BAR Meeting  
September 14, 2011

**ISSUE:** Permit to Demolish/Request for Alterations

**APPLICANT:** American Day School by Masood Amintinat

**LOCATION:** 1108/1112 Oronoco Street

Figure 8: Proposed South Elevation.

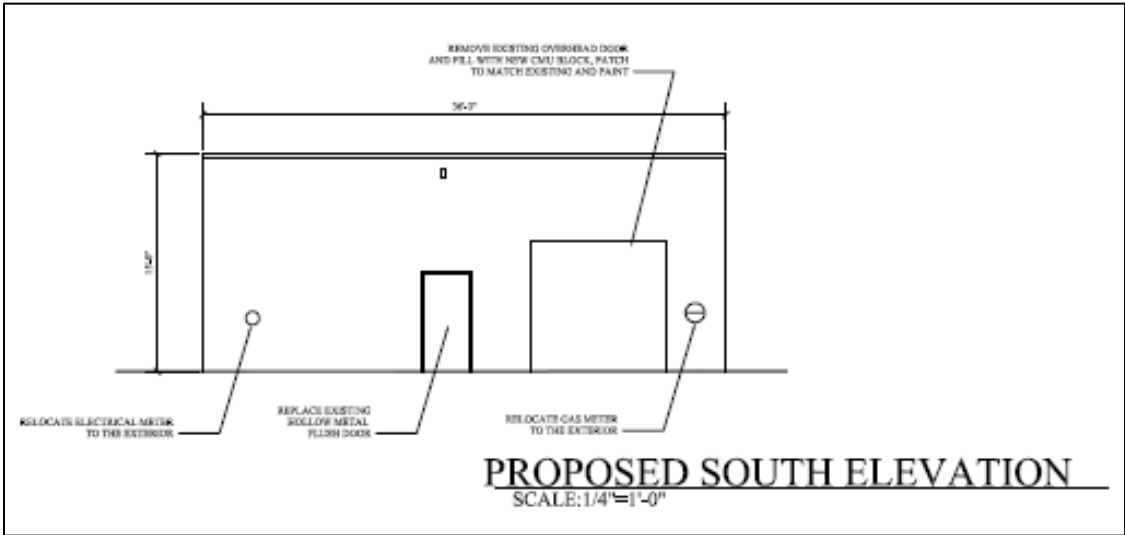
While Staff would prefer for the electric and gas meters to be located on the interior of the building and that they be remote reading, the applicant has chosen the least visually prominent façade (south) for the relocation and Staff can, therefore, support the relocation.

The HVAC unit and line is currently located at the front of the building, directly on the northeast corner of the roof. BAR Staff did not approve the current location of the unit and applauds the applicant on their decision to relocate the HVAC unit on the roof from the north to the south of the building. However, due to the narrow width of the building, Staff believes that the unit may still be visible from some locations and may, therefore, require screening. Staff, therefore, recommends that the Board approve a waiver of rooftop screening, with the condition that Staff work with the applicant in the field to place it in the least visible location.

1. That the fence be constructed of wood or a solid, millable and paintable material such as fiber-cement or PVC;
2. That that the awning is anchored to the masonry building through the mortar joints;
3. That all of the hollow metal flush doors are painted to match the exterior wall surface;
4. That the Board grant a waiver of rooftop screening, with the condition that Staff work with the applicant in the field to place the HVAC unit in the least visible location on the southern portion of the roof.

Figure 9: Proposed West Elevation.

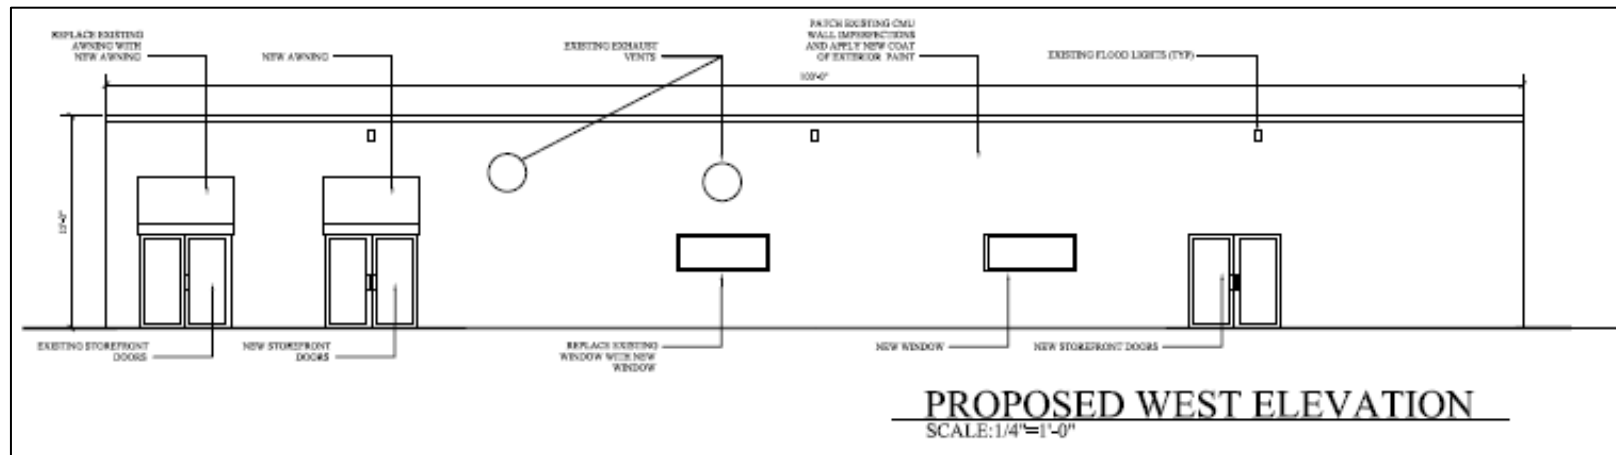
The applicant wishes to fence in a majority of the western side of the property in order to enclose a playground area for the children attending the American Day School. Staff supports the construction of the 6 foot high, solid fence in its proposed location, set back twenty-three feet from the front property line, as there are no front yard setback requirements in the CSL zone and the fence is located within the property line. In regards to material, Staff can support a wood fence or a solid, millable and paintable material such as fiber-cement or PVC, but no vinyl or hollow composite is permitted by the *Design Guidelines*.

The applicant is proposing one new awning and the replacement of the fabric on the two existing awnings. The proposed awning will match the existing awning and all three will be covered in a black, Sunbrella fabric so that there is a consistent appearance along the front and side of the building. These awnings meet the requirements outlined in the *Design Guidelines* for size, design, and materials. Additionally, the proposed awnings do not detract from the current style of the building, but add visual interest to the otherwise plain façades. Staff recommends a condition of approval specifying that the awning is anchored to the masonry building through the mortar joints.

Figure 10: Proposed East Elevation.

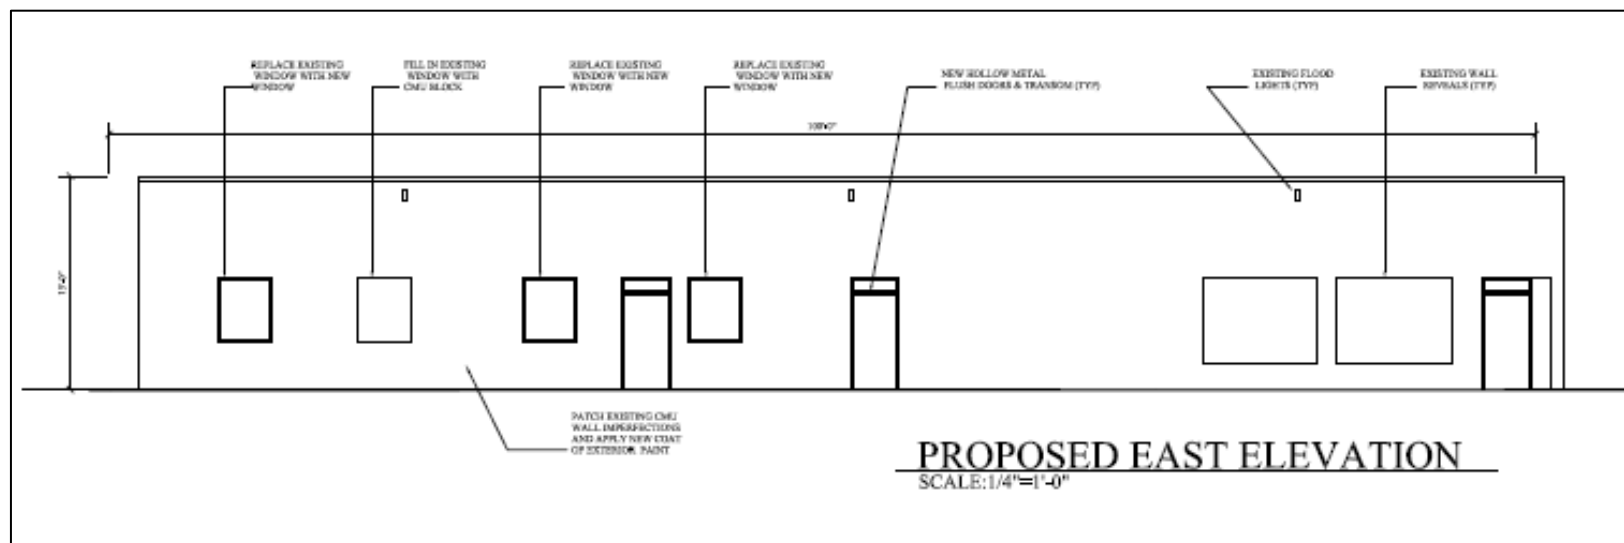
Staff supports the replacement of the existing hollow metal flush door on the rear elevation as it is a commercial building and an in-kind replacement. All of the hollow metal flush doors should be painted to match the exterior wall surface so that they are less visually obtrusive.
